ADDENDUM

OCTOBER 28, 2013

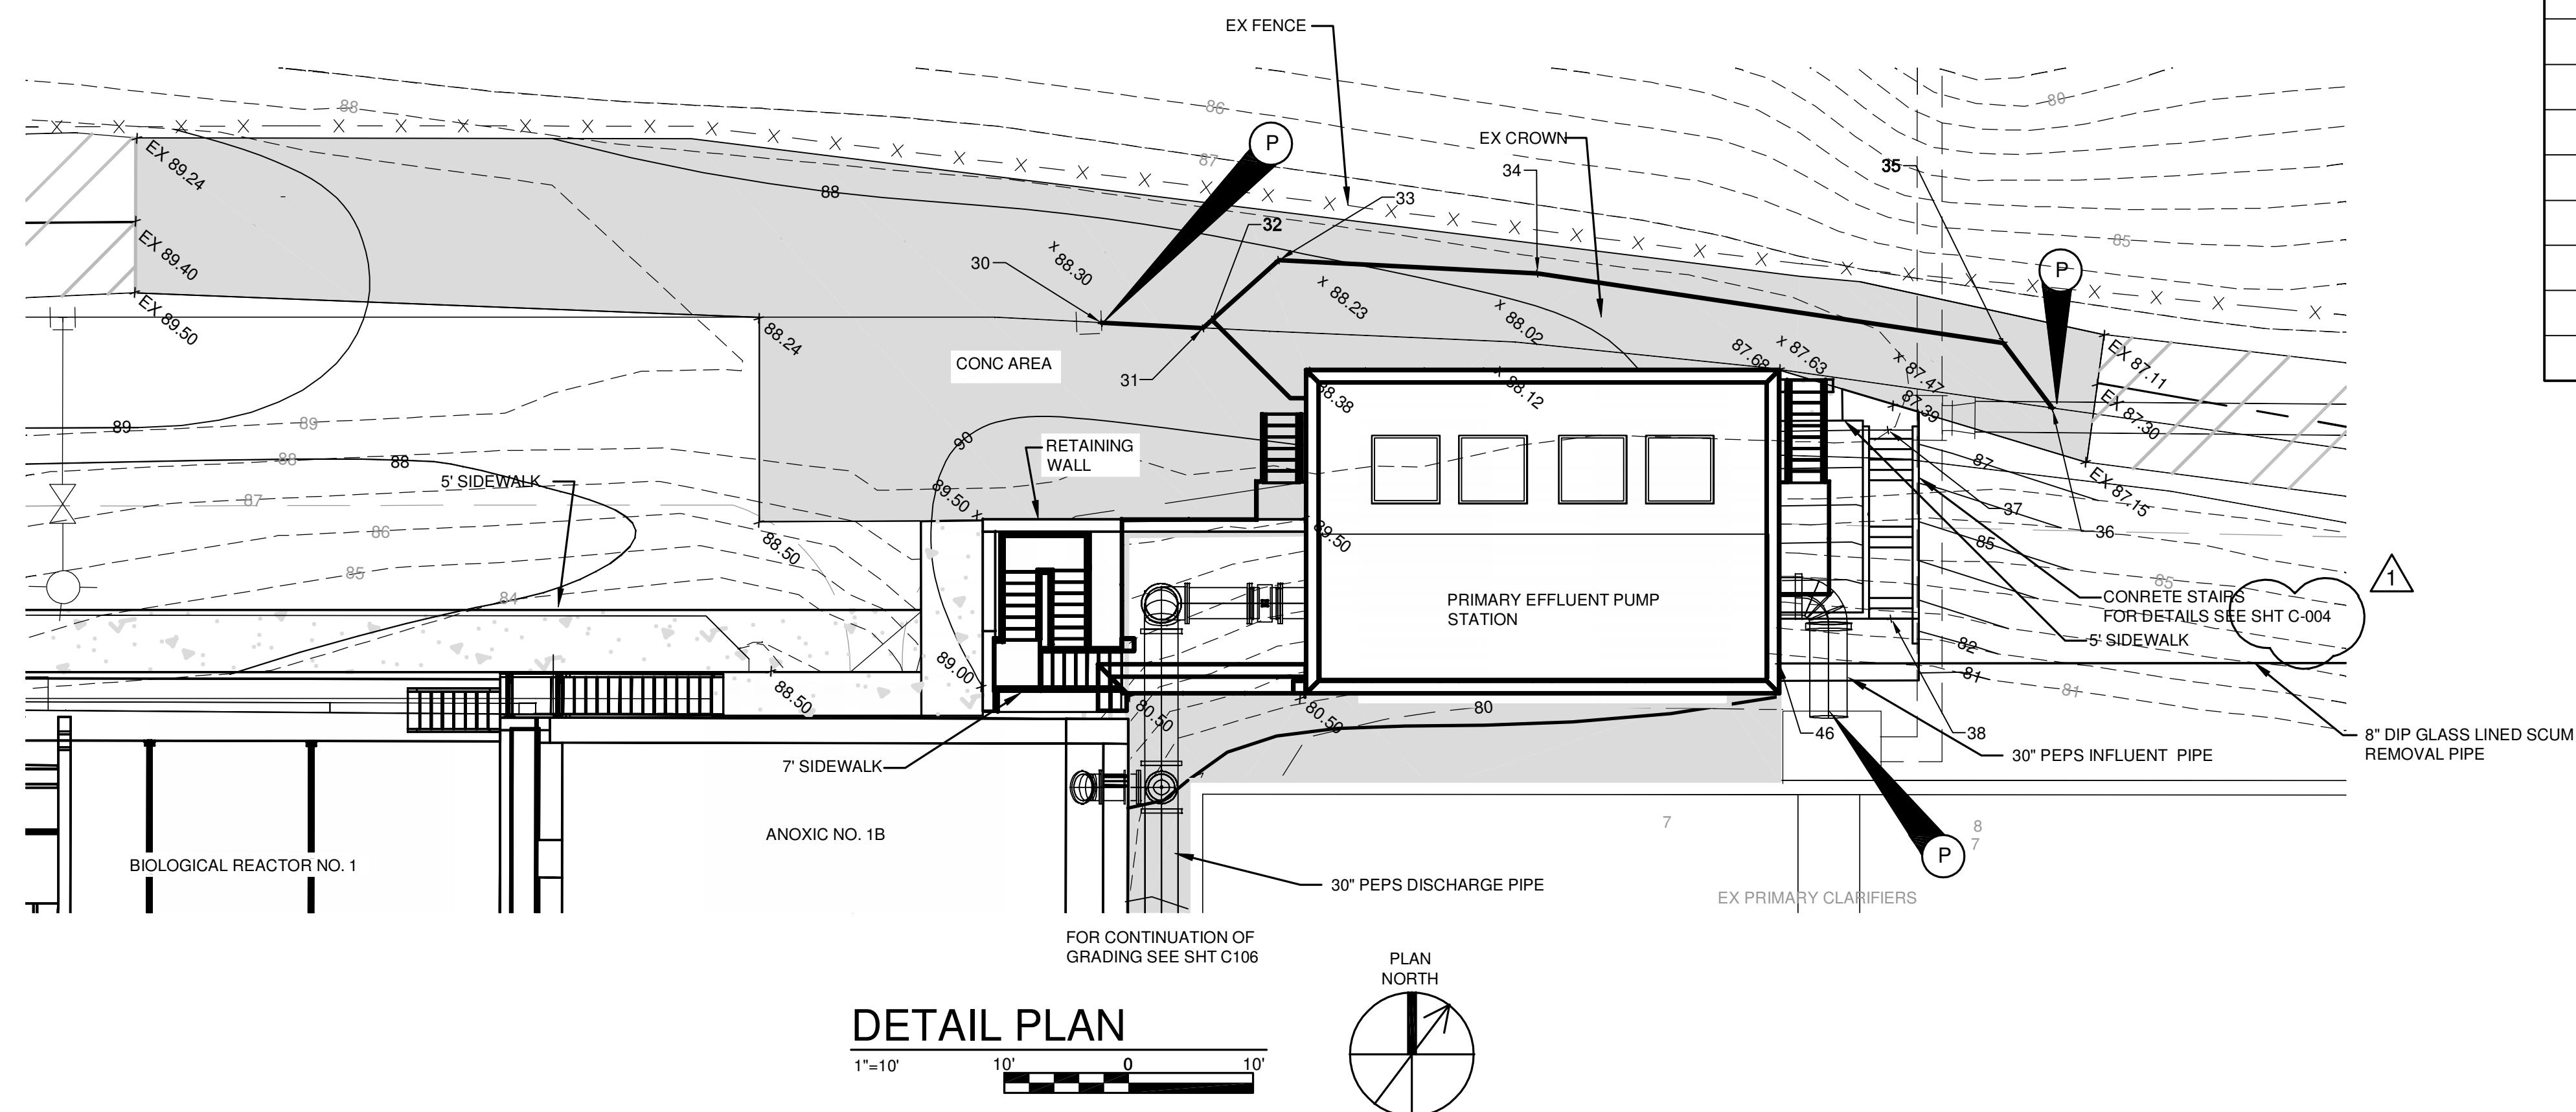
IN CHARGE OF	WAD					
DESIGNED BY	RWR					
CHECKED BY	RWR	1	10/28/2015	ADDENDUM NO. 2		WAD
DRAWN BY	AJP	0	09/23/2015	ISSUED FOR BID		WAD
		NO.	DATE	REVISION		INT

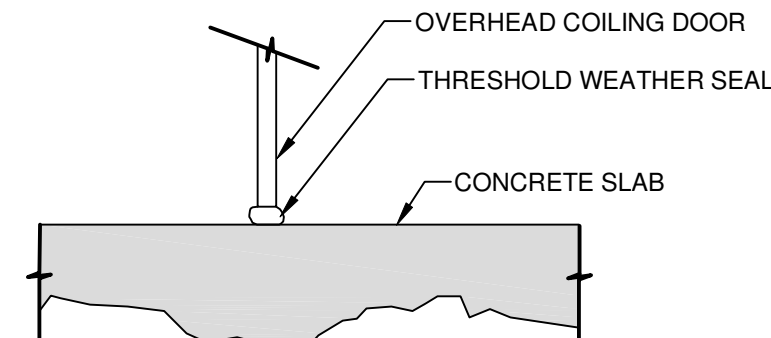
IN CHARGE OF	WAD				
DESIGNED BY	KGP				
CHECKED BY	RWR	2	10/28/2015	ADDENDUM NO. 2	KGP
		1	10/23/2015	ADDENDUM NO. 1	KGP
		0	09/23/2015	ISSUED FOR BID	KGP
DRAWN BY	AJP	NO.	DATE	REVISION	INT.

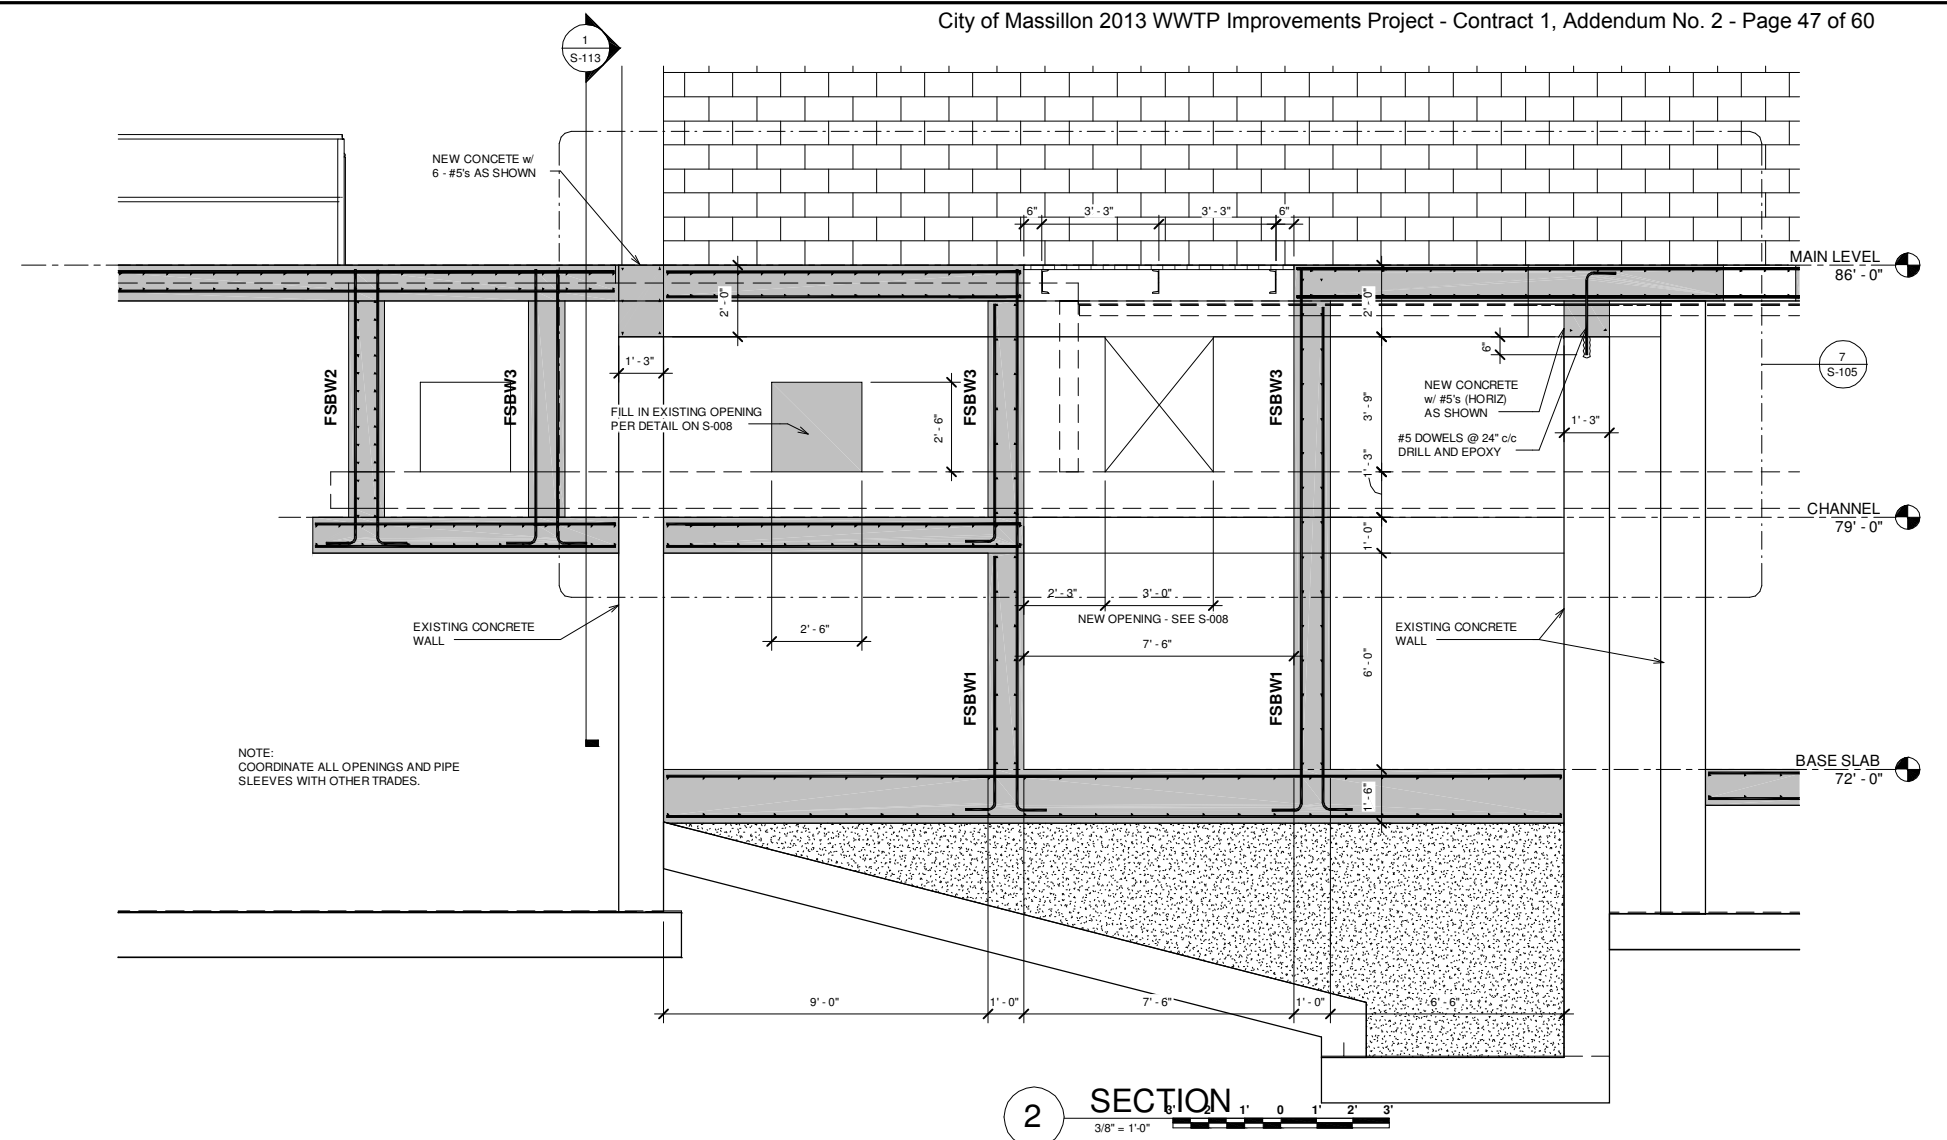
IN CHARGE OF	WAD				
DESIGNED BY	KGP				
CHECKED BY	PCC	2	10/28/2015	ADDENDUM NO. 2	KGP
		1	09/23/2015	ISSUED FOR BID	KGP
		0	03/19/2015	ISSUED FOR OEPA REVIEW	KGP
DRAWN BY	KGP	NO	DATE	REVISION	INT
